**Class II Permissive Change Letter**

FCC ID: 2AMTQHA88XX

Subject: Request Class II Permissive Change for FCC ID: 2AMTQHA88XX

Original  
Left  
Antenna

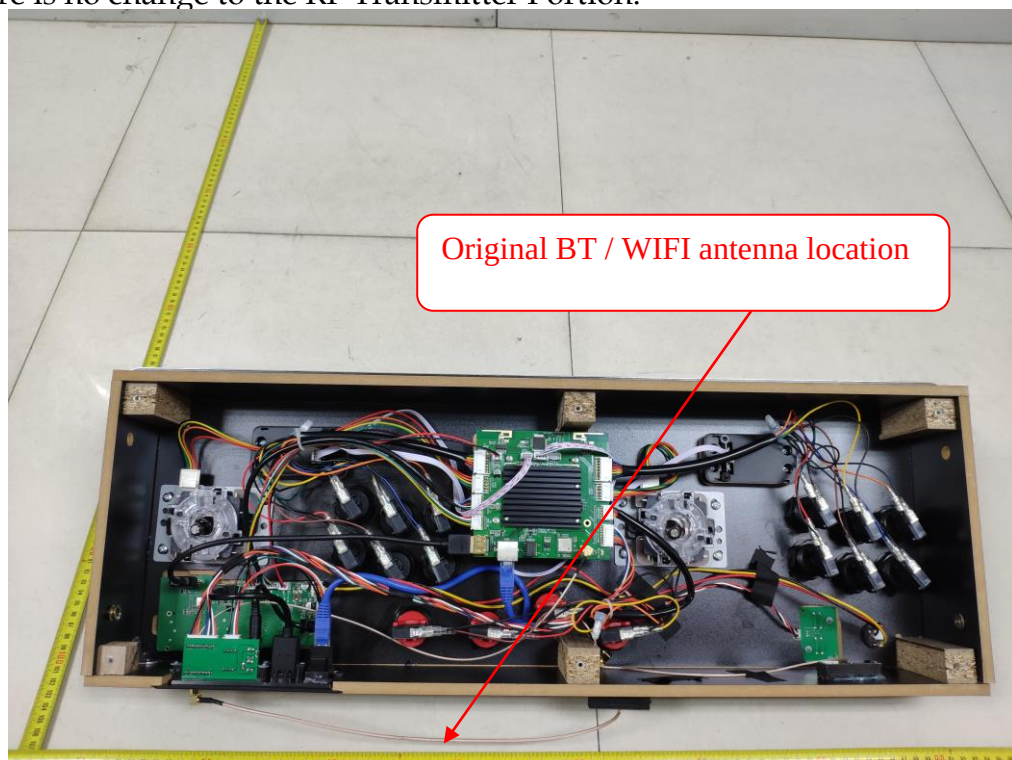
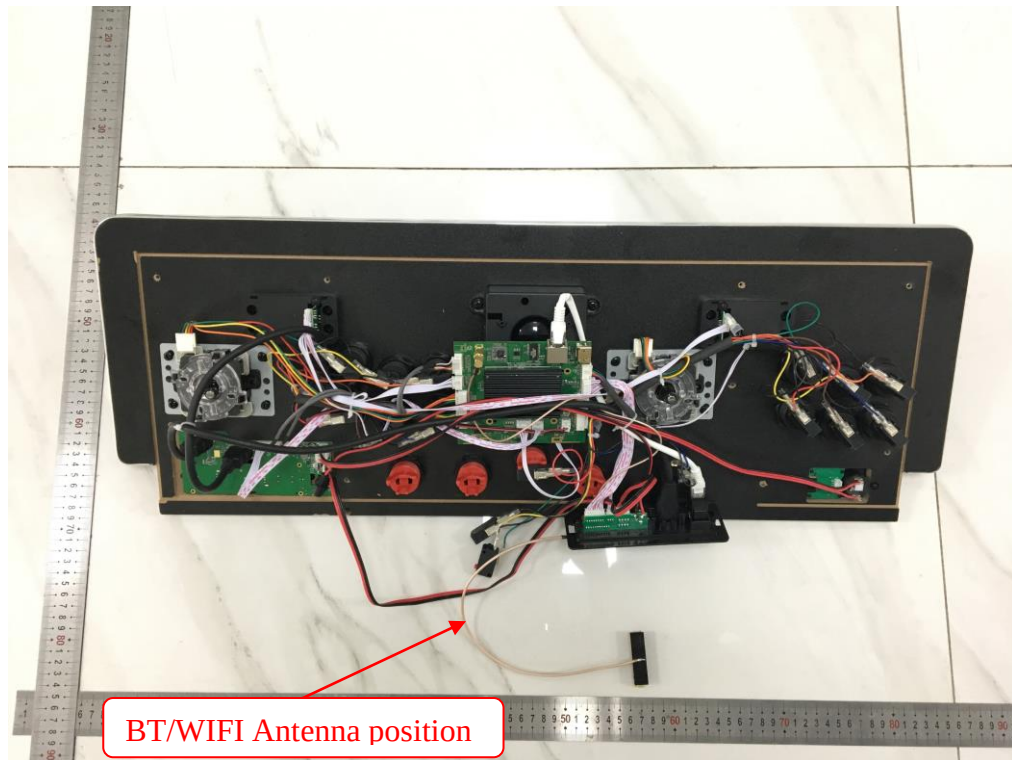
1. External photos not change;
2. This product has changed the PCB layout. The Bluetooth / WiFi antenna has been moved from the left side of the original PCB to the right side of the PCB. Please see the photos.
3. There is no change to the RF Transmitter Portion.

I attest that such change will not affect the RF function (the output power of new less than original grant) the RF function out of the grant conditions.
